ICHD - ENVIRONMENTAL HEALTH DIVISION

PERMIT # AP318764

SEPTIC: IMPROVEMENT PERMIT / AUTHORIZATION TO CONSTRUCT / OPERATION PERMIT / EXISTING SYSTEM

APPLICANT/OWNER: Kevin Chen

INITIAL SITE SKETCH

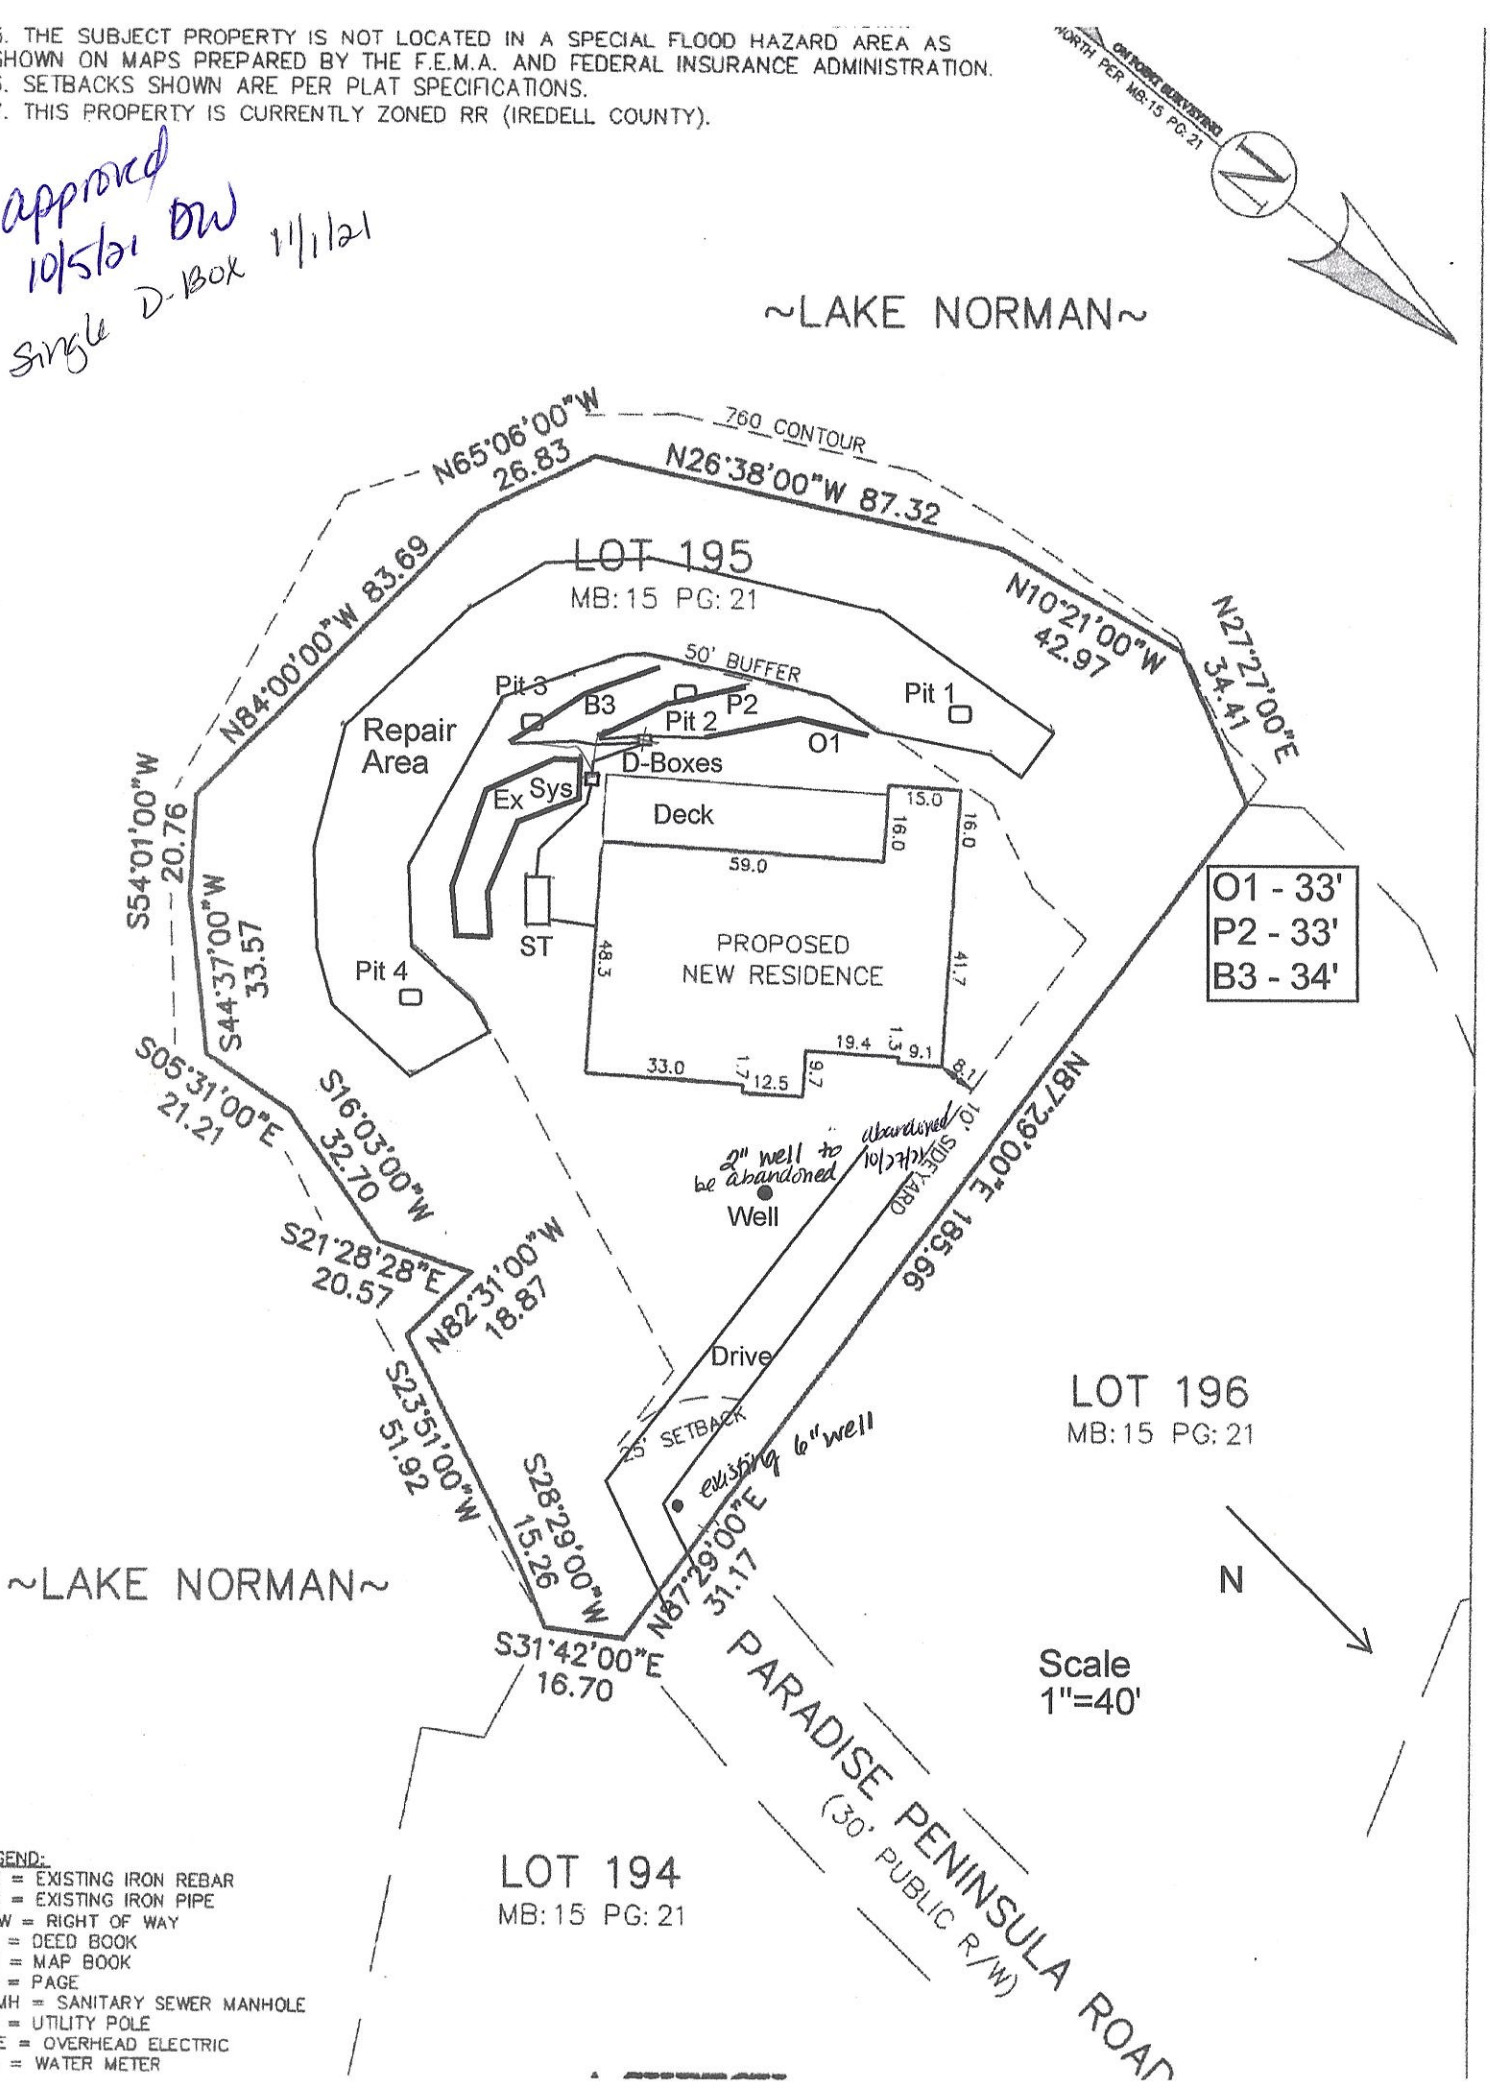
Comments / Conditions: Do not pave, grade, park, drive, or bury utilities in drainfield area. 50' buffer must be clearly staked during installation. Earthen dam end of bed before setting D-box. Set new tank

Keep D-boxes 5' or more off deck - ~~feed bed then~~ overflow to new lines.

Permit replaces previous permits - site plan changed, house

built over existing system

Due to elevation differences in new & old systems, distribution will be to feed all lines to the bed equally. 11/1/21

approved
10/5/21 DW
Single D-Box 11/1/21
